Re: Seneca Meadows Valley Infill Expansion Application
Response to Request for Additional Technical Information
Seneca Meadows Inc. (SMI) Landfill
DEC ID 8-4532-00023/00041 and 00001
Seneca Falls (T), Seneca (C)

On behalf of Seneca Meadows, Inc., Cornerstone and GHD have developed responses to the comments in your letter dated March 11, 2022 for the 6 NYCRR Part 360 Permit Application for the SMI Valley Infill development at the Seneca Meadows Landfill in Seneca Falls, New York. The New York State Department of Environmental Conservation (NYSDEC) comments are listed below with responses in italics immediately following.

FIGURE 3

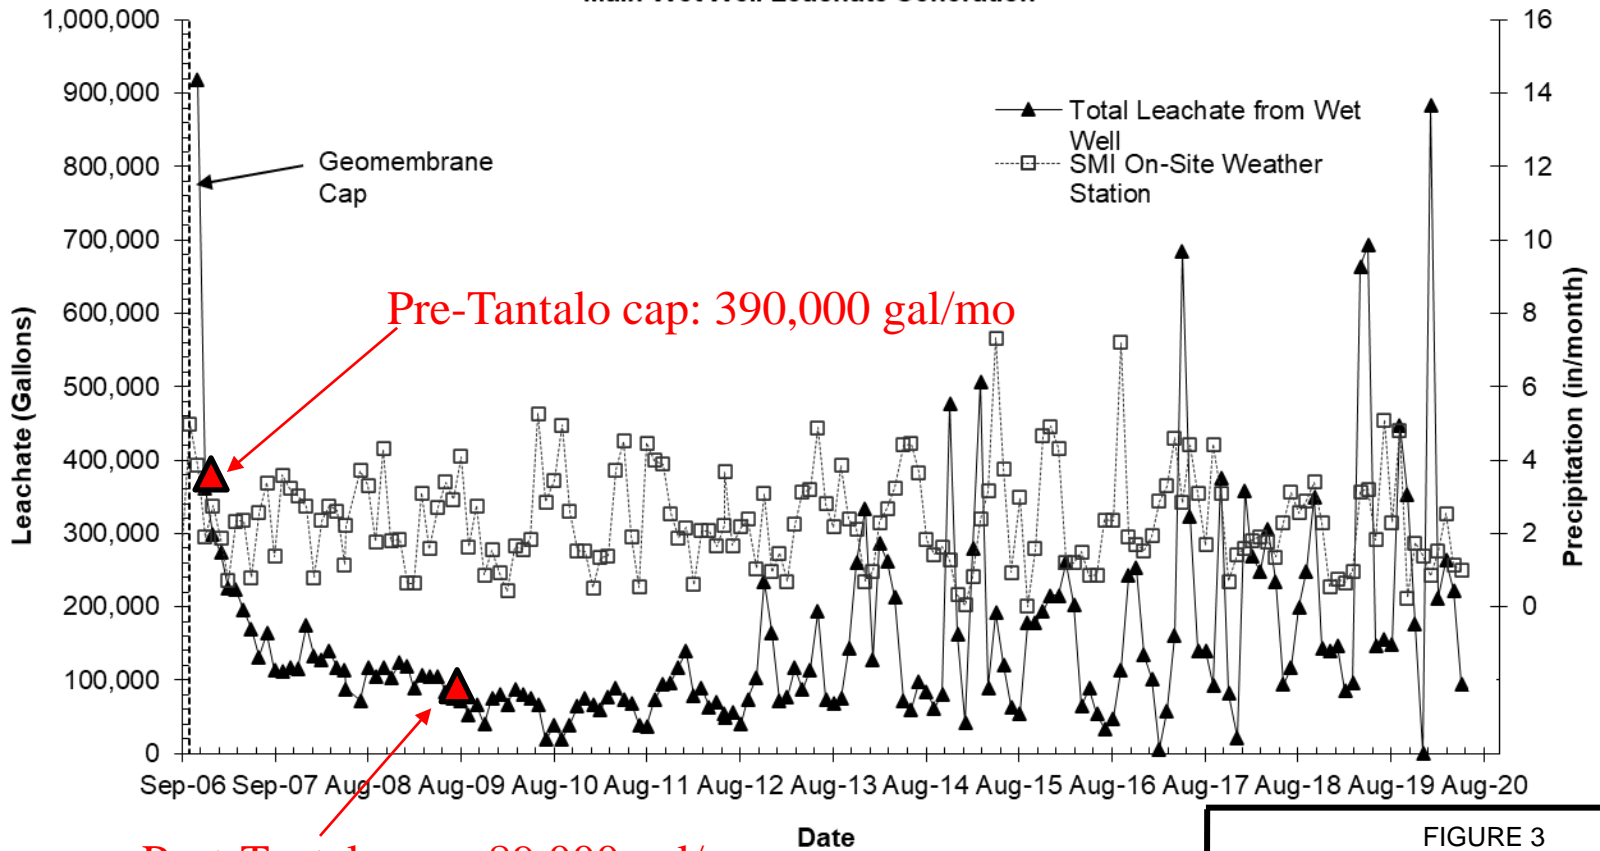
4. Attachment 7, Figure 3: Please explain why 390,000 gal/mo was used as the pre-cap leachate rate instead of an average of all pre-cap leachate generated. In addition, post 2012 leachate rates are more sporadic and less stable; however, is 89,000 gal/mo a conservative number to use in the groundwater model calculations? Would it make more sense to take an average of leachate rates from 2007 to present (i.e., all post-cap conditions)?

Installation of the Tantalito cap began in September 2005 with the placement of low permeability soil and was completed in October 2006 with final placement of the geomembrane liner. Since the leachate collection line was not completed prior to September 2005, actual pre-cap leachate rates were not available for averaging as the comment suggests. As shown on the referenced figure, which is attached to this letter (Attachment 2), the first reported flow rate from the LCL was in October, 2006 and reported a flow of approximately 920,000 gal/mo. However, this rate likely included a significant component of stormwater from on-going construction and was thus not considered representative of pre-cap leachate generation. Subsequent post-cap data from 2007 and 2008 show a steady decline in flow as a result of reduced infiltration and mound reduction. Thus, taking an average of these data would also not be appropriate for use in model pre-cap calibration as suggested in the comment. Based on the available data, a rate of 390,000 gallons per month was used for calibration, as it represents the closest field-measured rate to pre-cap conditions without the influence of stormwater infiltration from construction.

With respect to post-cap flow rates, Figure 3 illustrates a period roughly between August 2009 and early 2015 during which leachate flow had stabilized at a baseline rate of approximately 89,000 gallons per month. This period follows the transient period of decline due to cap placement (2006-2008) as discussed above and is prior to the influence of flow from other sources which have caused spikes in the flow rate of the LCL. The impact of these extraneous activities have been documented in prior Tantalito Periodic Review Reports (PPR) to include:

- Changes in groundwater levels due to a temporary increase in groundwater infiltration associated with the construction of the Part 360 landfill expansion (e.g., temporary ponding while pumping is performed due to temporary construction conditions).
- The potential for short circuiting of ponded stormwater flow through more permeable media such as aggregate used in construction.
- Operation and maintenance of the leachate collection system, such as collection pipe cleaning.

Further discussion of leachate flow is provided in Section 5.1.2 of the most recent PPR and Combined Annual Report #9 (September 1, 2021). As a result, averaging flow rates during this period as suggested would overestimate the actual groundwater contribution to the LCL and will thus not be used for model calibration.
